**OFFICE OF PLANNING & ECONOMIC DEVELOPMENT
ANALYSIS FOR A CASINO OVERLAY SITE PLAN REVIEW (CITY COUNCIL)**

**PROPERTIES BOUNDED BY MAIN STREET, UNION STREET, STATE STREET AND EAST
COLUMBUS AVENUE
CASINO OVERLAY SITE PLAN REVIEW**

MGM SPRINGFIELD – SITE PLAN REVIEW

Summary Report: Plan/Design/Development Aspects

GARAGE LEVEL FIVE

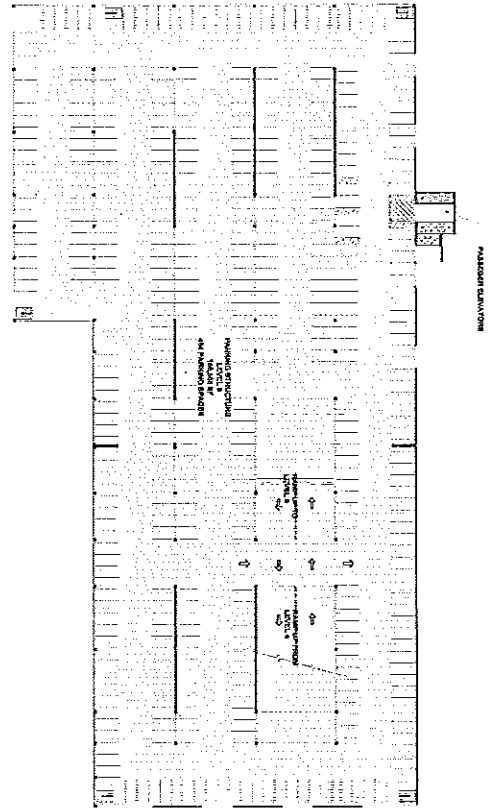
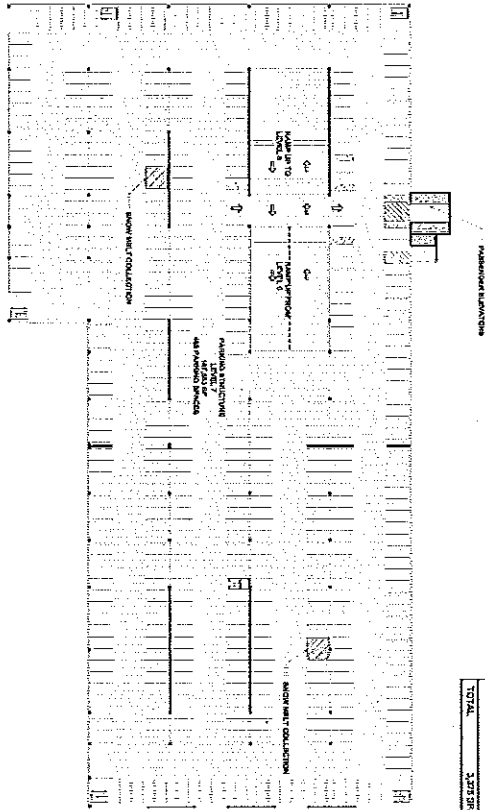
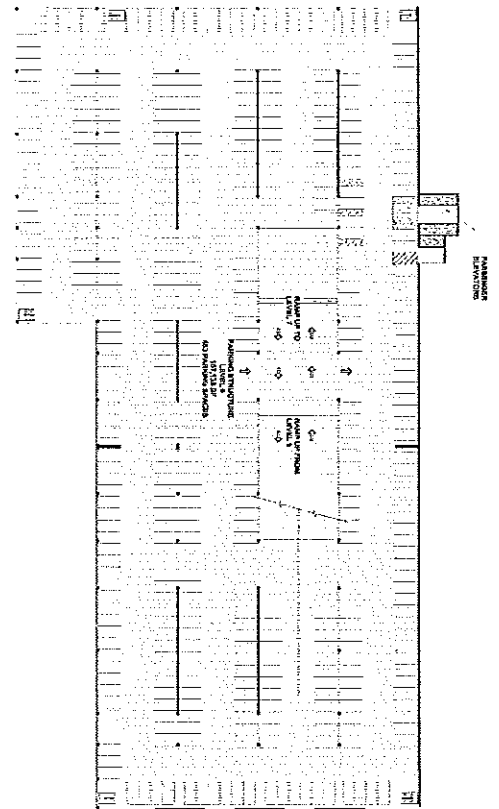
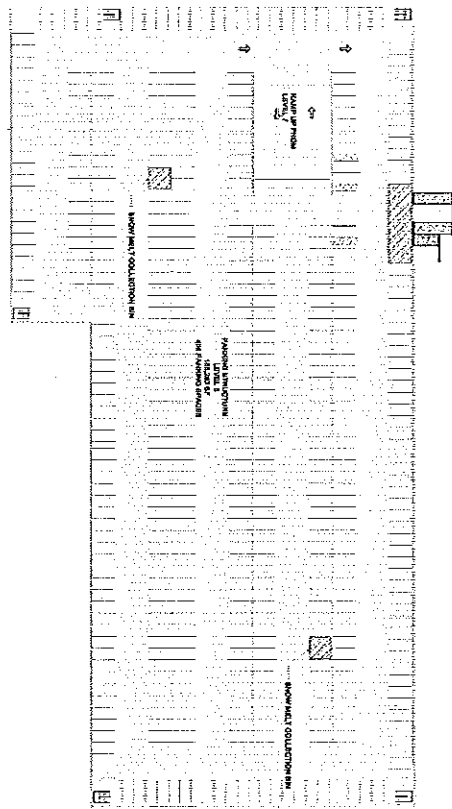
additional architectural details were going to be added to the Bliss Street side of the garage but that the East Columbus Avenue/Union Street facades were less detailed and lacking in architectural interest. After numerous meetings with the developer, a number of positive changes are being proposed which will address the concerns listed above. It is the understanding of the staff that these changes are still being worked on and that final plans will be submitted as part of the Site Plan Review hearings. It would be the staff's recommendation that any plans submitted at the hearings be incorporated into the final approval.

The elevations of the garage were the subject of much dialogue during the review process. Several advancements in the latest plans and drawings include a change in façade coloration between the two garage massings in order to differentiate and modulate the overall scale of the structure, redesign of the garage corner elements to create more pleasing architectural definition, introduction of a rooftop parapet design element to serve as both an architectural feature and to embody project signage and graphics in a manner which is integrated into the Springfield skyline and captures attention from the higher speed highway traffic. Although not concluded, it remains our recommendation that some form of urban landscaping be integrated into the new rooftop parapet design to provide a unique, year round image and soften the overall mass and scale of the garage complex.

ENLARGED HOWARD STREET ELEVATION
(PART 1 OF 2)

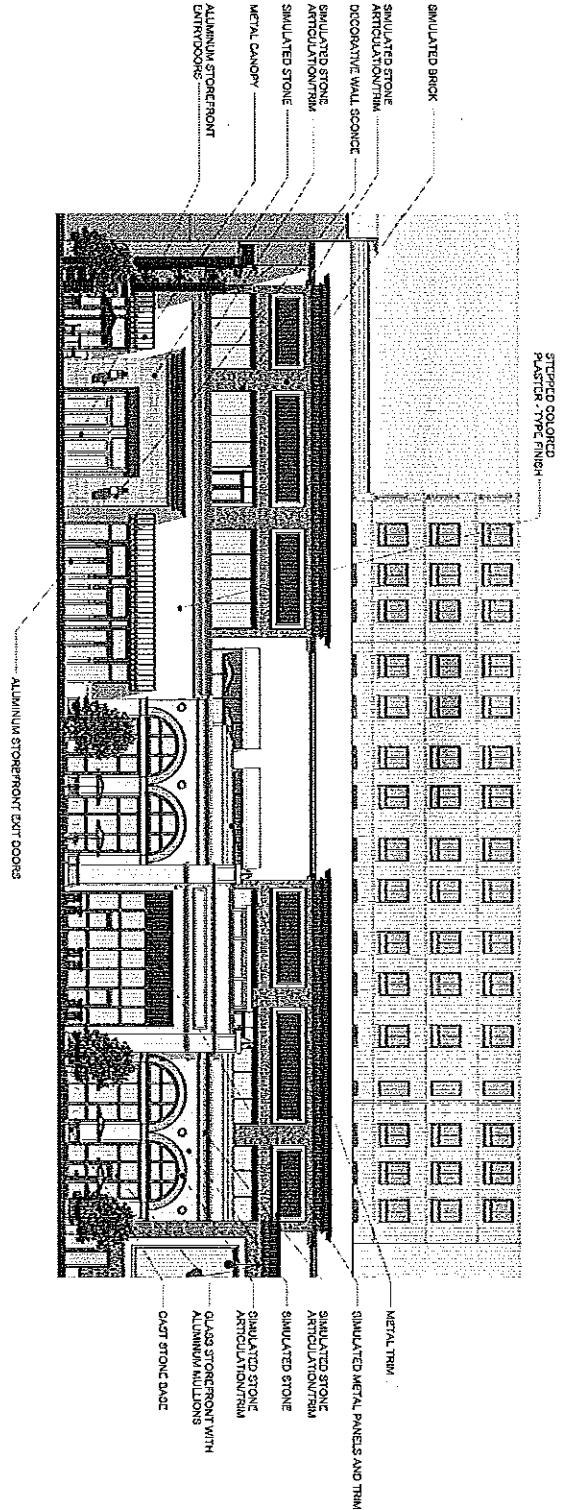
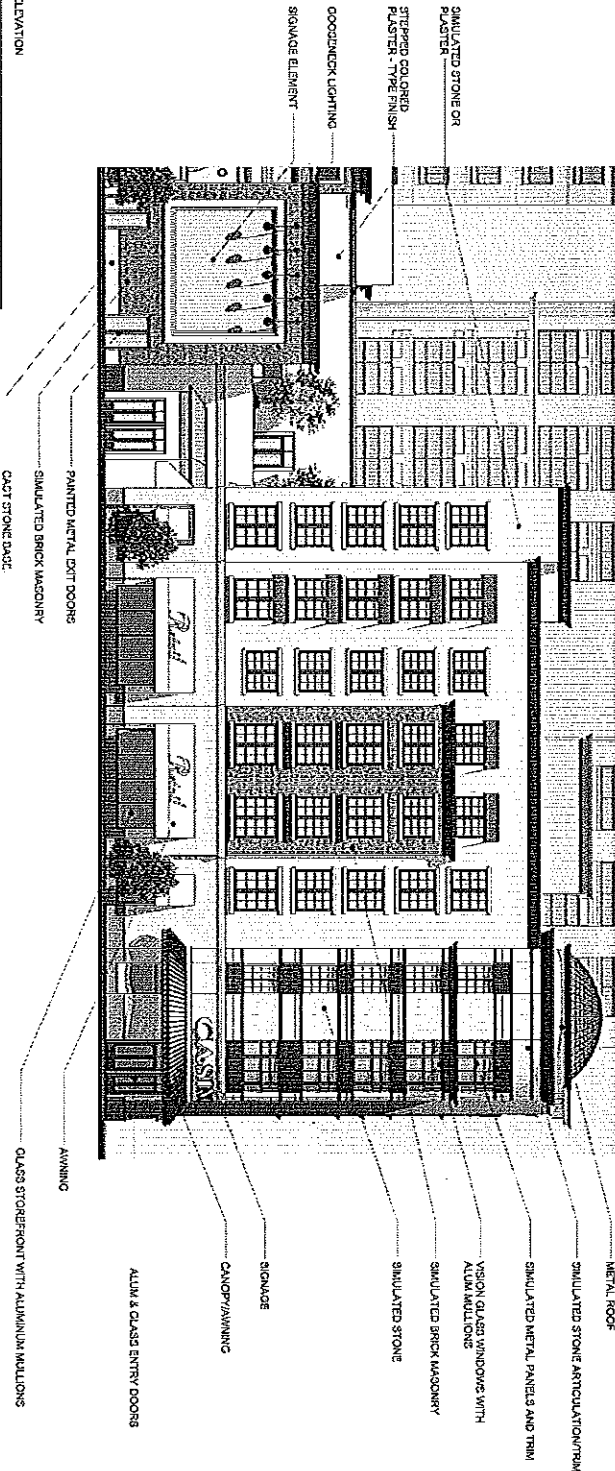
The site plan review process also addressed advancements to the overall massing and articulation of facades, entries and design character/quality. Areas such as the character of the entertainment plaza facades were discussed in detail and embellished to ensure proper articulation, fenestration and integration as an extension of the downtown urban fabric.
